ADDENDUM NO. 2

Colton High School – Baseball & Softball Field Lighting Upgrades

DSA #04-124412

RCA Project No. 1-15-117

ELECTRICAL - BASEBALL
FIELDS - ENLARGED

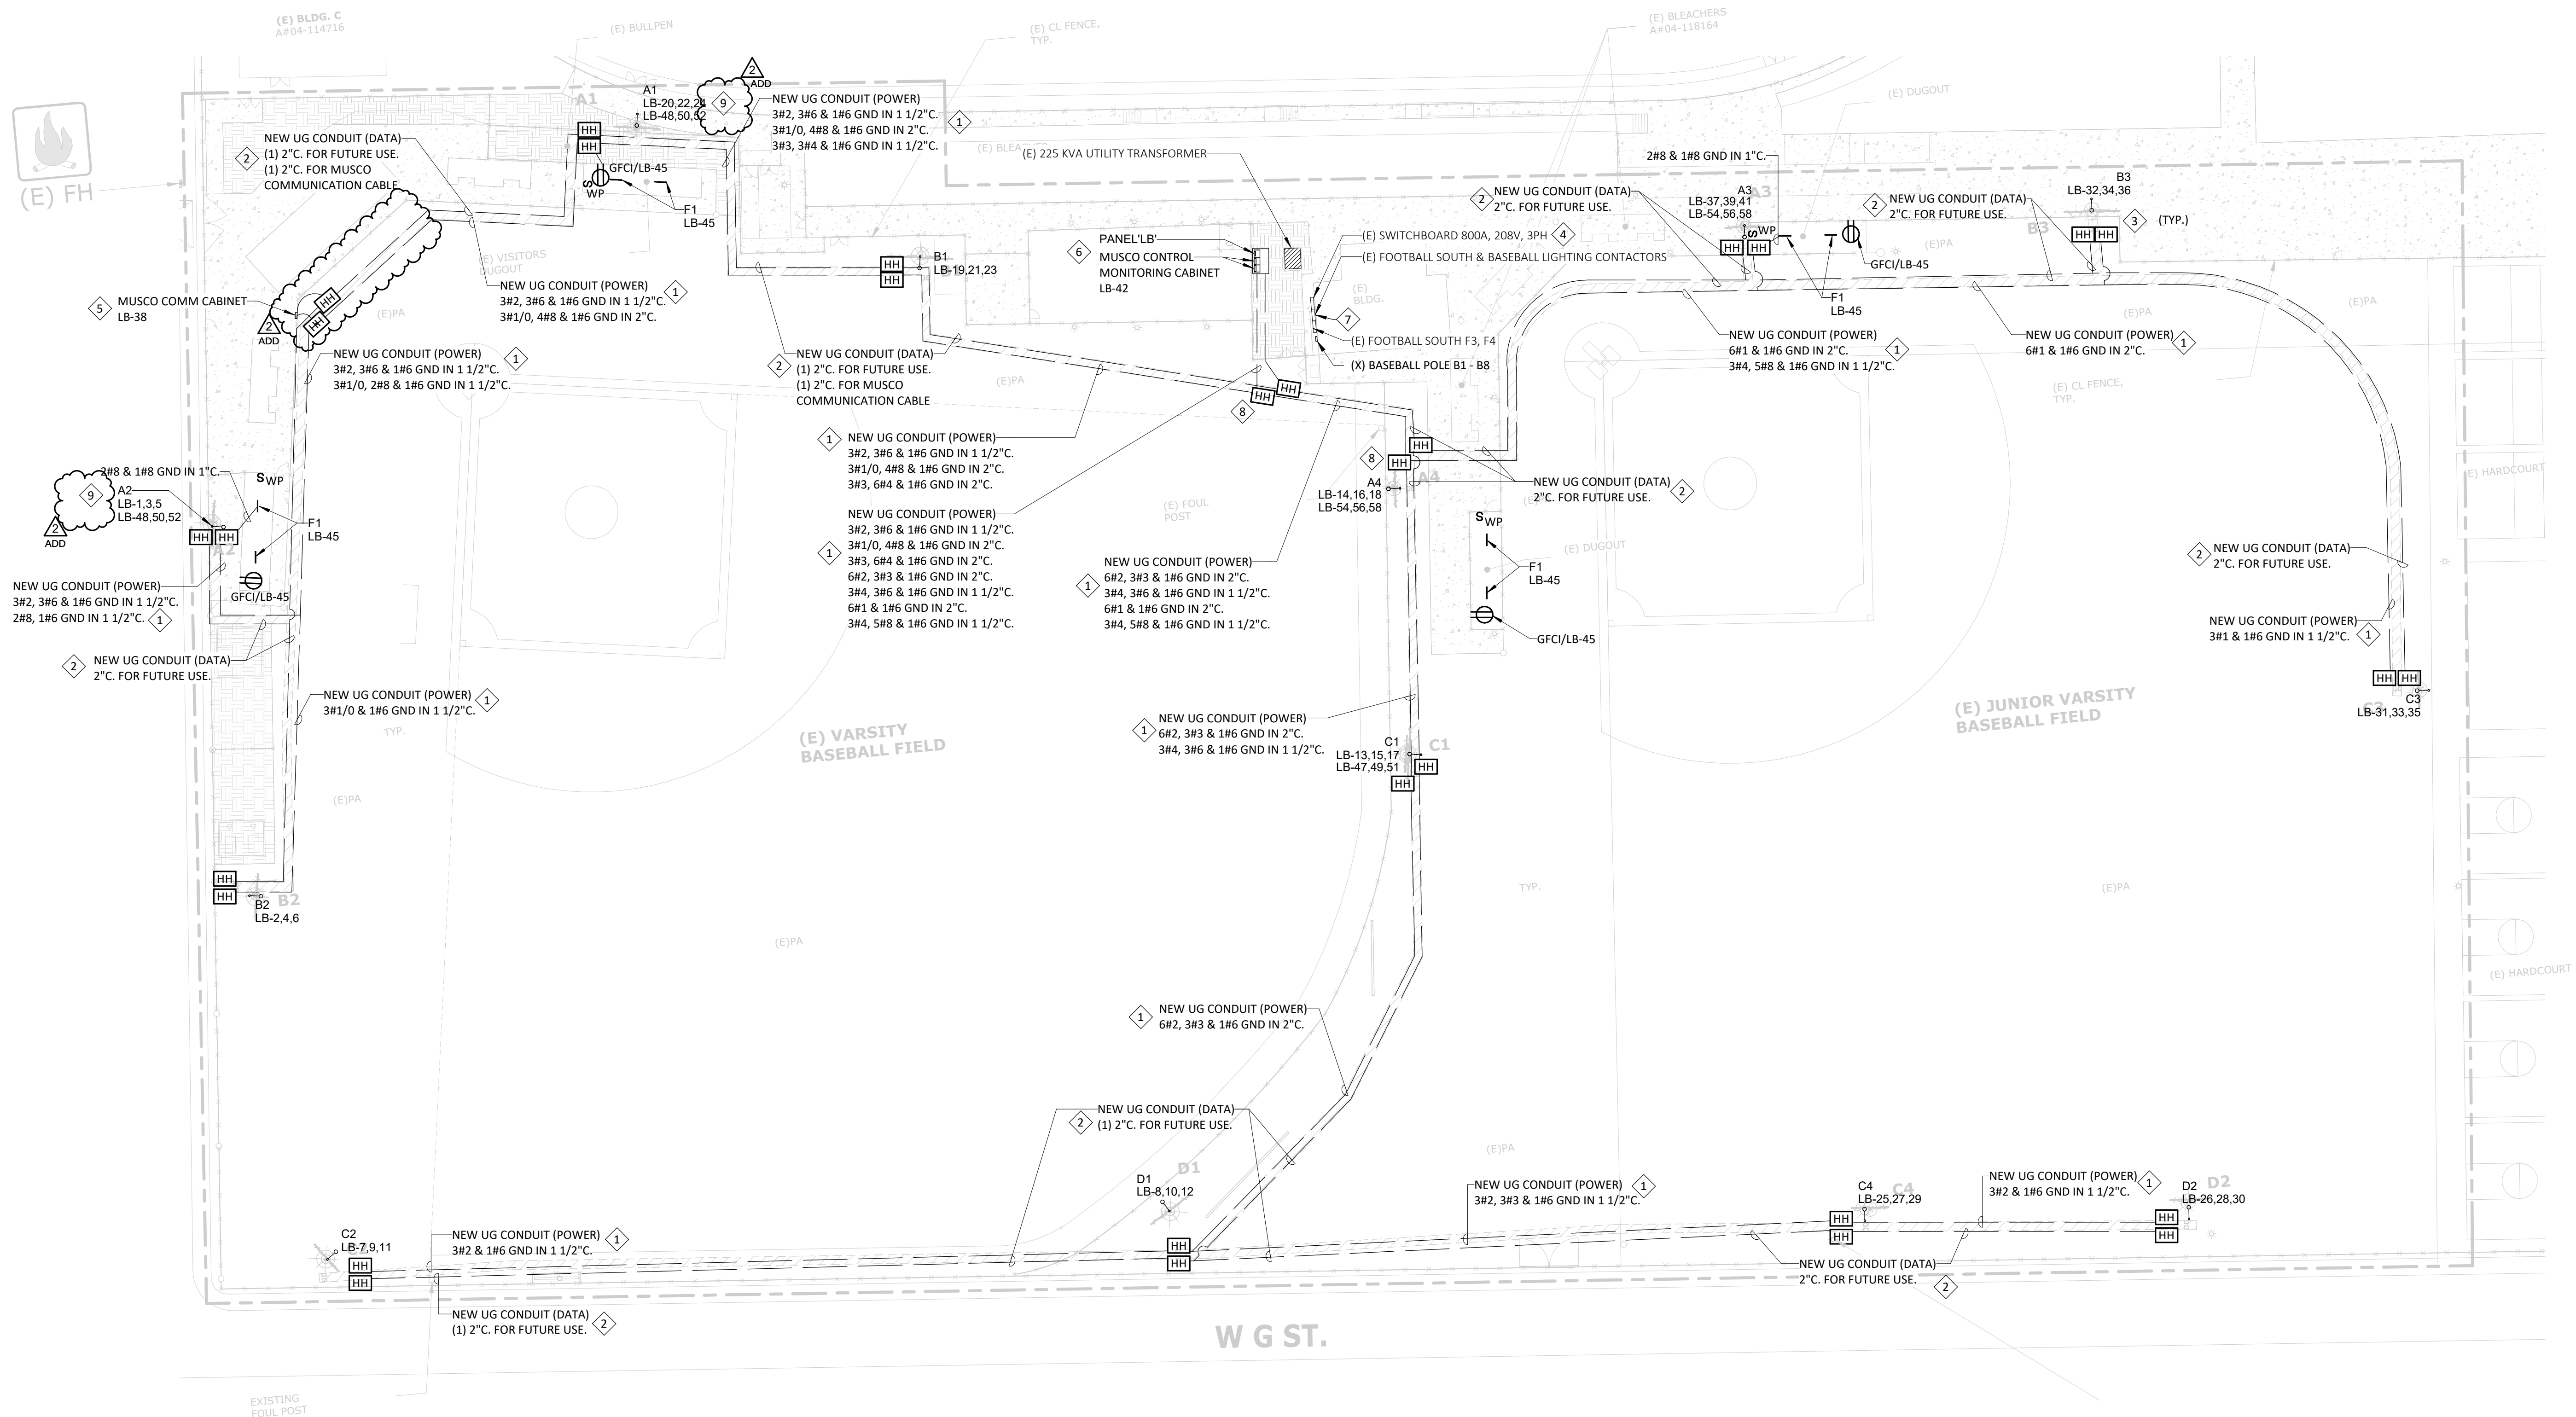
- Item No. 2.1 Reference Sheet E-7.1 – ELECTRICAL-BASEBALL FIELDS – ENLARGED
2.1.1 Revise per clouded areas of attached sheet and items listed below
 a) Revise General Note #5
 b) Revise Keynote 5, NEMA enclosure size and detail reference.
 c) Add Keynote 9.
 d) Revise location of Musco Comm Cabinet in plan.
- Item No. 2.2 Reference Sheet E-7.2 – ELECTRICAL-SOFTBALL FIELDS – ENLARGED
2.2.1 Revise per clouded areas of attached sheet and items listed below
 a) Revise General Note #5
 b) Revise Keynote 5, NEMA enclosure size and detail reference.
 c) Add Keynote 9.
 d) Revise location of Musco Comm Cabinet in plan.
- Item No. 2.3 Reference Sheet E-9.1 – ELECTRICAL DETAILS
2.3.1 Revise per clouded areas of attached sheet and items listed below

7	REMOVE CONTACTORS ASSOCIATED WITH REMOVED LIGHTING POLES IN THE BASEBALL FIELD.
8	PROVIDE SIZE 'A' HAND HOLE AT THIS LOCATION PER DETAIL 2/E-9.1.
9	PROVIDE SPEAKERS MOUNTED TO MUSCO LIGHTING POLES AT THIS LOCATION. TWO (2) SPEAKERS PER POLE. UTILIZE MUSCO-FURNISHED MOUNTING BRACKET ON POLE. PROVIDE SPEAKER WIRING BACK TO COMMUNICATION CABINET IN LOW-VOLTAGE CONDUIT. SEE DETAIL 7/E-9.1.

COMMUNICATIONS ENCLOSURE MOUNTING DETAIL

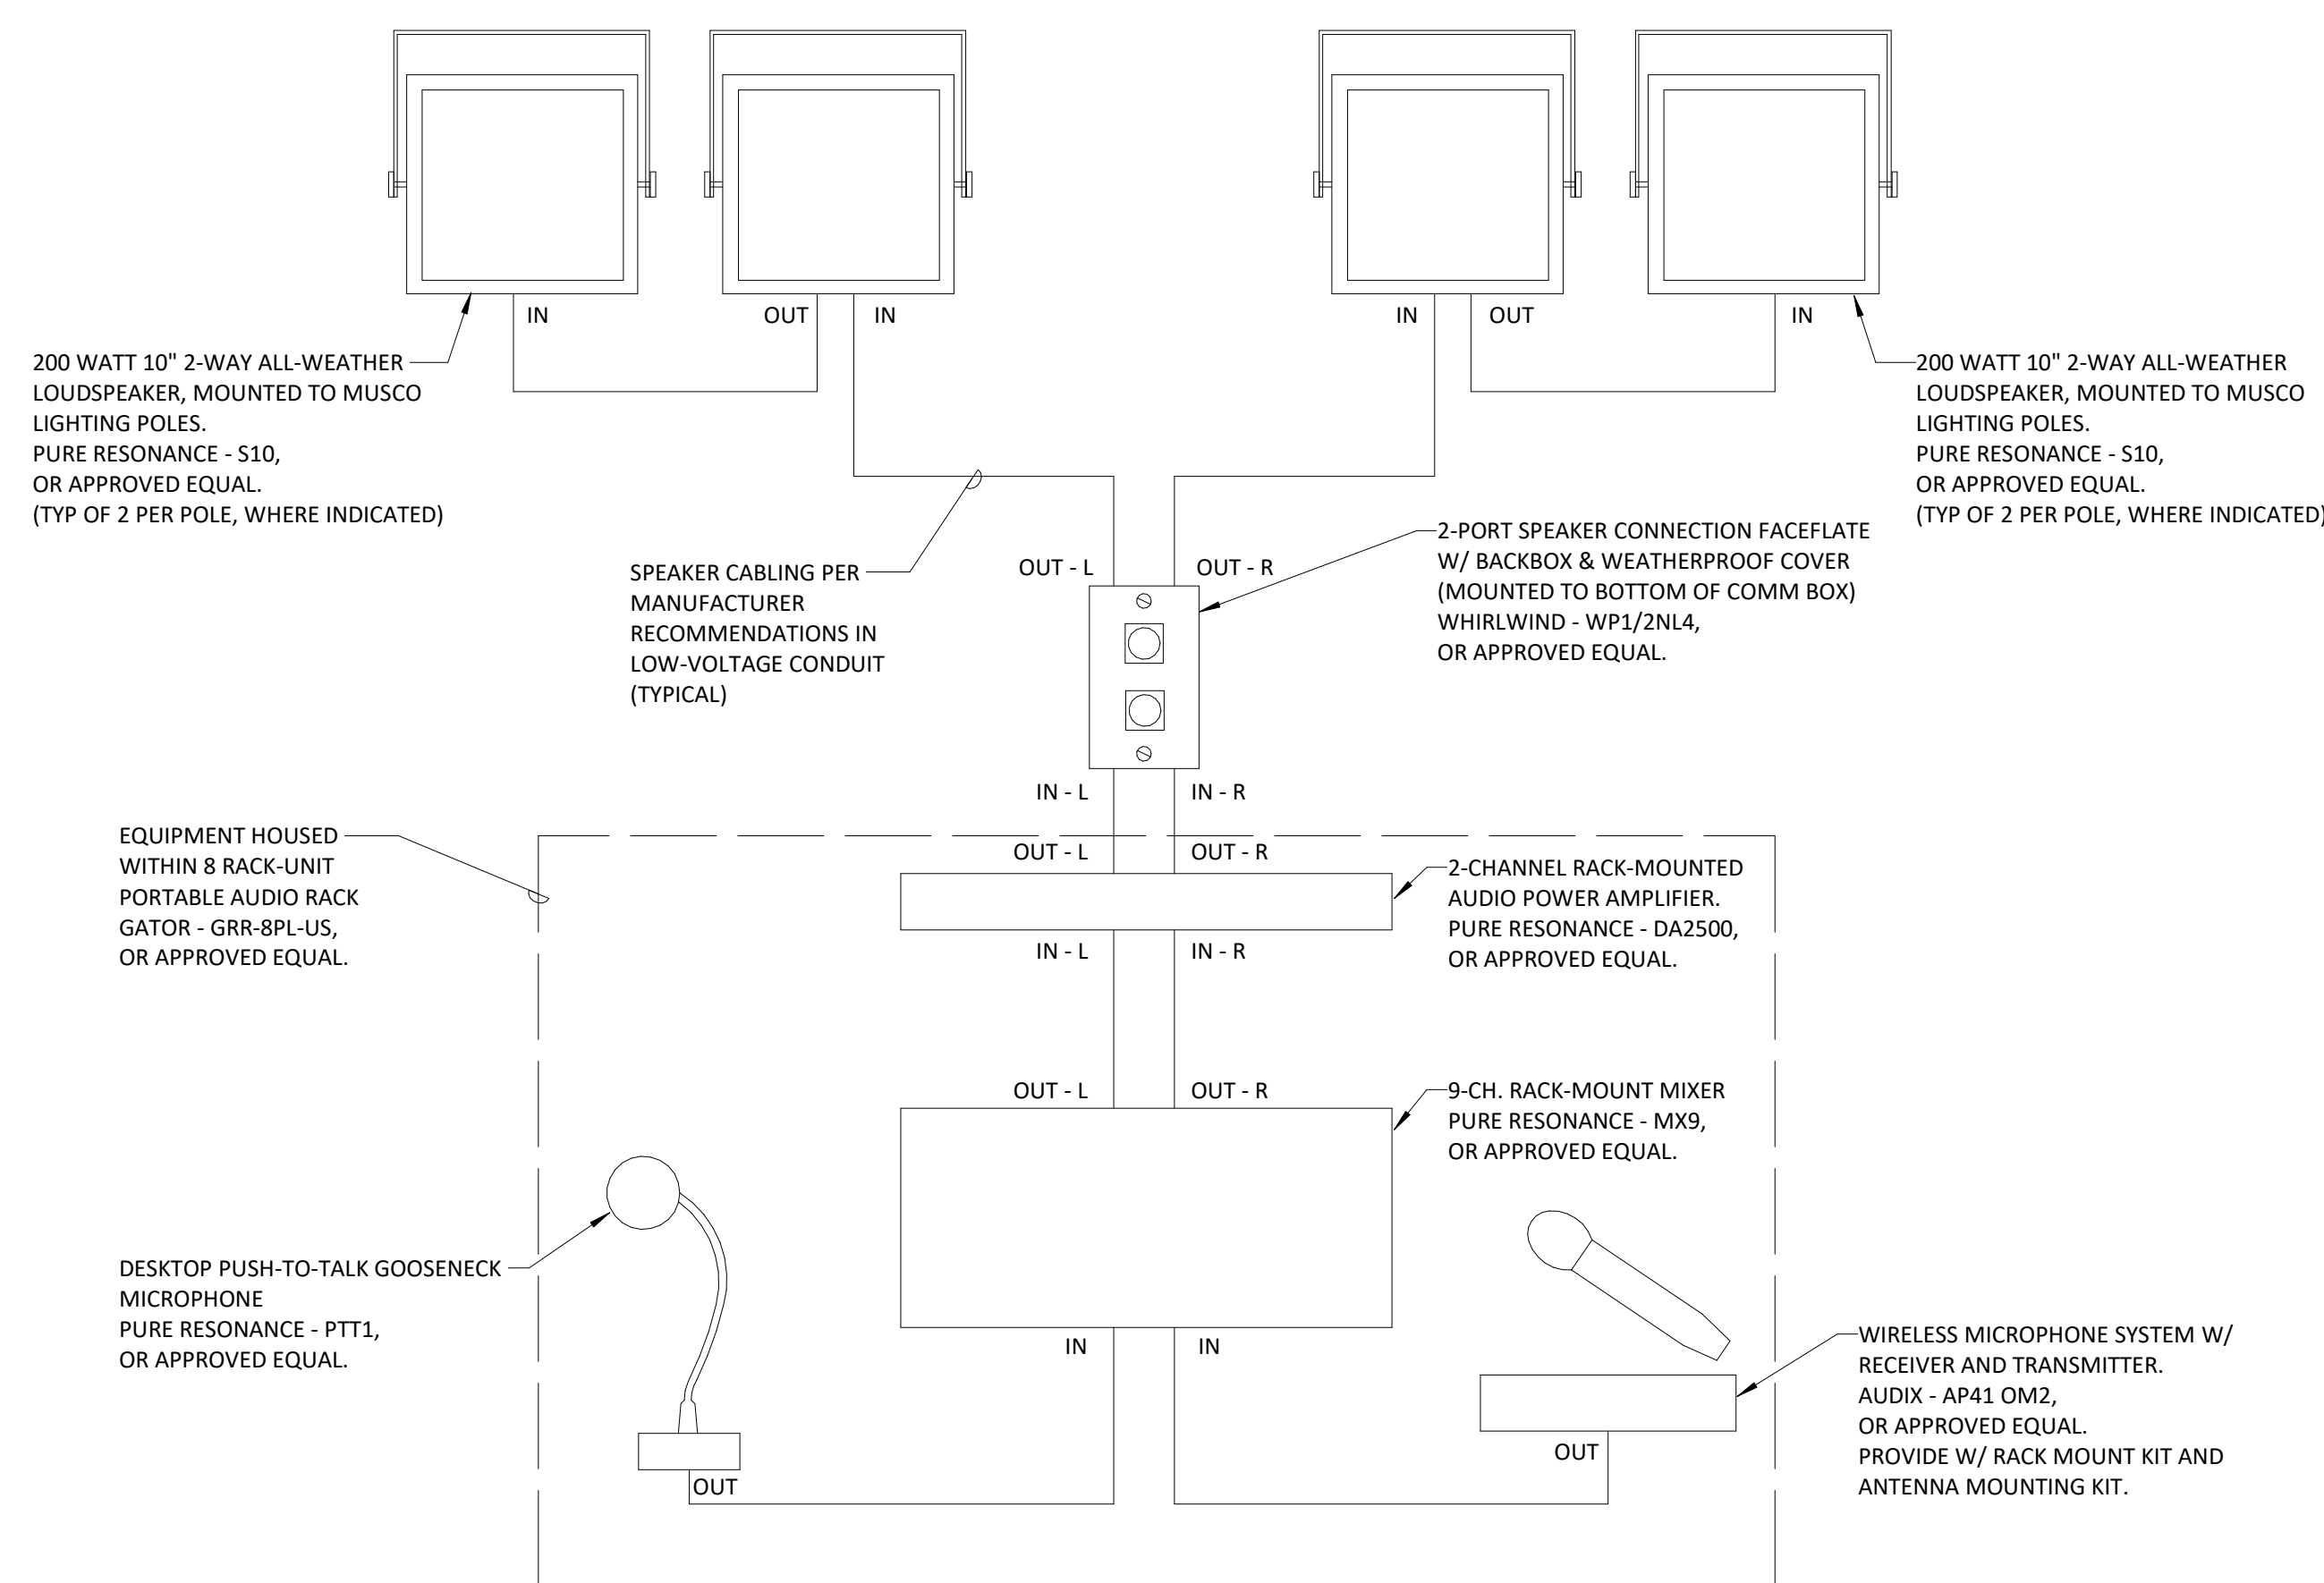
- a) Add detail 6/E-9.1 – Communications Enclosure mounting detail.
- b) Added detail 7/E-9.1 – PA Speaker System Diagram.
